Subject: Turfhill Park: Review of Aboricultural Report

## SLP - Review of the Applicants Aboricultural Report

PICTURE 1

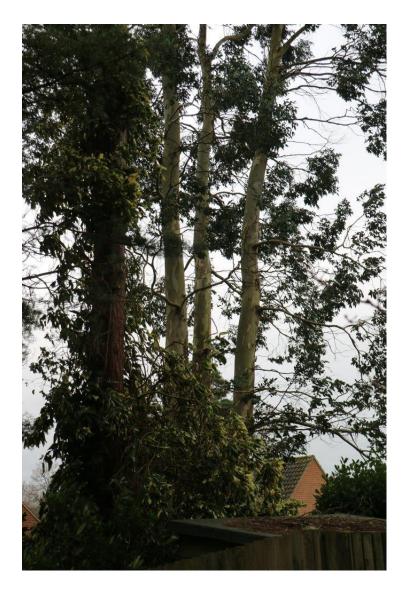
- i. A Pinus sylvestris in good condition with a stem diameter of 487 millimetres located midway between trees T49 and T58 on their plan that was missing from the plan despite its proximity to the intended route. Picture 1 centre tree
